Re: NIRB 03MN107: Comments Received for Agnico Eagle Mines Ltd.'s "Meadowbank Gold Project 2013 Annual Report"

The following information is provided in response to comments and recommendations made by Government of Nunavut, Aboriginal Affairs and Northern Development Canada, Environment Canada, Fisheries and Oceans Canada, Health Canada and Transport Canada June 9th, 2014, regarding the Meadowbank Gold Project 2013 Annual Report.

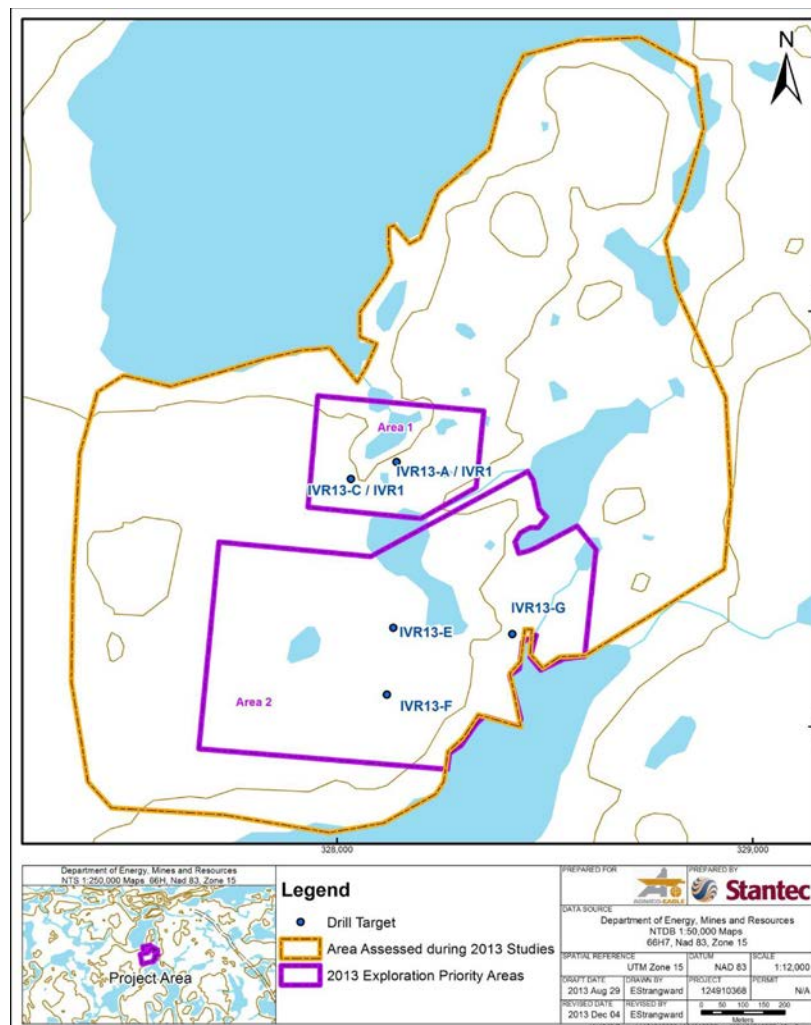
5- Appendix G19: Report: Archaeological Impact Assessment Meadowbank Exploration: With reference to Appendix G19: Report: Archaeological Impact Assessment Agnico Eagle Meadowbank 2013 Exploration Studies, an archeological impact assessment study was conducted in 2013. The final report was submitted to CH on March 31, 2014. While CH considers that the proponent has complied with the requirements set out by our department, geo-spatial clarification is required with regards to the additional surveyed areas to the north, west and east of the Priority Areas (Areas 1 and 2).

To confirm the department’s approval of the report, can the Proponent confirm that the latter areas are included (shown) in Figure 1-3 and that they are contained within

the boundaries of Areas 1 and 2 as shown? If not please provide an adequate explanation as to why they were excluded.

The Priority Areas (purple boundary – Areas 1 & 2) were created and examined for archaeological sites mainly because the five drill locations (blue dot) are within these Priority Areas. As more time was available to the field, AEM archaeologists extended this area to ensure the terrain surrounding the Priority Areas was also evaluated to prevent any future disruption (illustrated on Figure 1-3). These areas are within the orange boundary in the Figure below. The locations of these additional terrains are:

- To the north of Priority Area 1;
- The area to the west of Priority Areas 1 and 2; and
- Area extending east of the Priority Areas.

In summary, all the terrain within the “Areas Assessed during 2013 studies” (orange boundary) were visited and inspected for archaeological sites. This included the five proposed drill locations (blue dots) and the assessment of the exploration Priority Areas (purple boundary). No archaeological sites were identified.
